Staff Report Z-28-22-8 July 11, 2022

Planning Commission Hearing Date: August 4, 2022

Request From: S-1 (Ranch or Farm Residence District)

Request To: R1-8 (Single-Family Residence District)

SITE PLAN

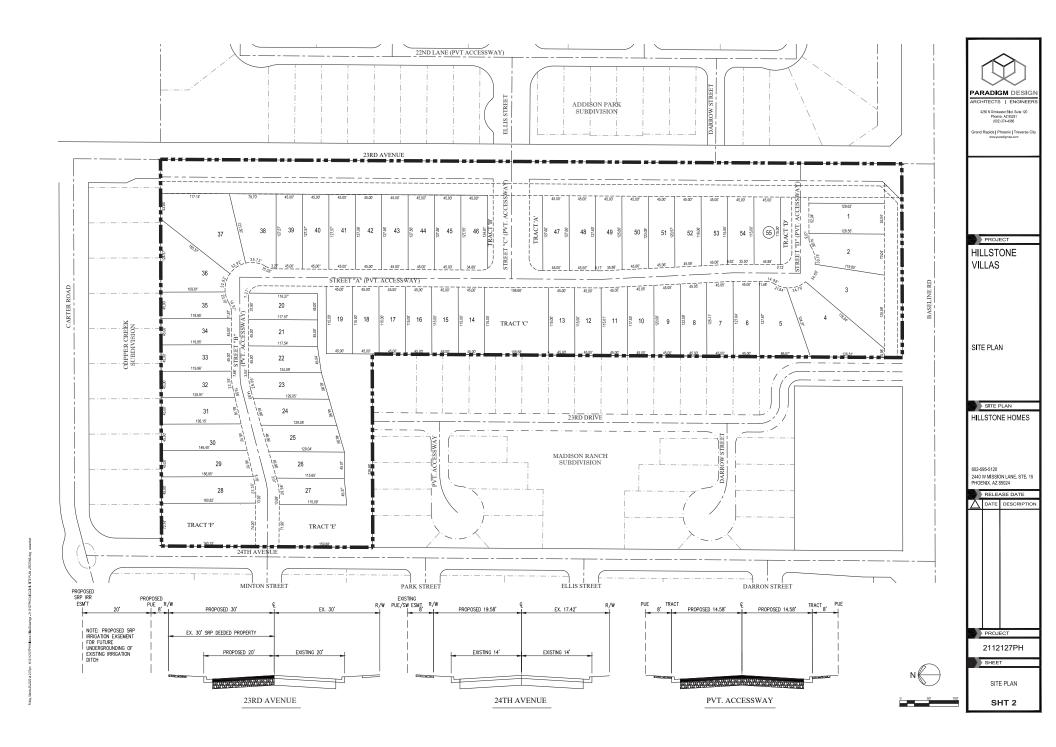
Conformance to the conceptual site plan provided by the applicant is not recommended by staff as this plan would require a technical appeal, via a separate process, to develop a new subdivision without connecting to the adjacent street stub on 23rd Drive. However, staff recommends Stipulation Nos. 1 and 2 to ensure the development does not exceed the number of lots depicted in the conceptual site plan and for a larger percentage (10 percent) of open space to be provided on the site than required by the Zoning Ordinance. Stipulation Nos. 3 through 5 as recommended by staff, address landscaping enhancements along perimeter landscape setbacks to help maintain the character of the neighborhood and provide a transition in concert with the goals of the Rio Montaña Area Plan.

- 20. The developer shall connect to 23rd Drive, or dedicate a 50-foot radius cul-de-sac and construct a 45-foot turning radius on site at the termination of 23rd Drive, as modified and approved by the Planning and Development Department.

PRELIMINARY WALL PLAN

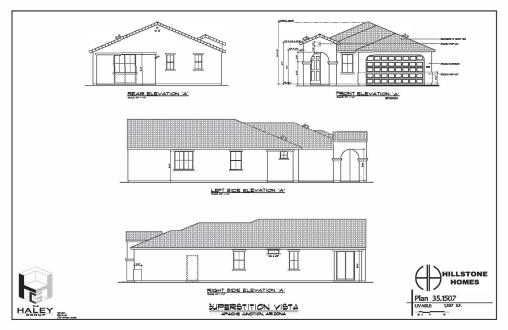
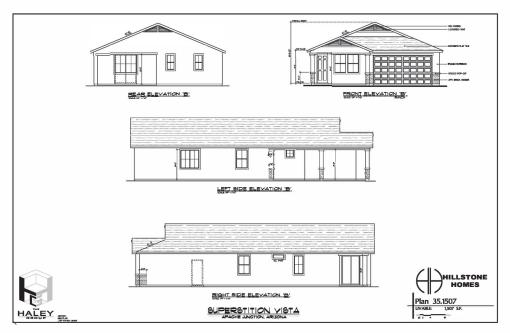
Perimeter wall enhancements along adjacent public streets are also addressed in Stipulation No. 8 and will help to improve the streetscape by providing visual interest via wall-offsets and material and textural differences.

- a. Partial view fencing, which may include solid columns up to 24 inches in width, shall be utilized where walls are proposed around open space areas, the partial view fencing shall be a maximum 3-foot solid wall and 3-foot view fencing.

- b. Perimeter walls bounding the rear or side yard property lines of residential lots along 23rd Avenue, 24th Avenue, and Baseline Road shall include minimum three-foot offsets, and material and textural differences, such as stucco, and/or split face or slump block or a decorative element, such as tile or stamped designs, as approved by the Planning and Development Department.

- c. The wall layout depicted in the wall details (wall elevations) plan shall be modified where necessary to accommodate site layout changes that avoid conflicts with the Zoning Ordinance or City Code requirements.
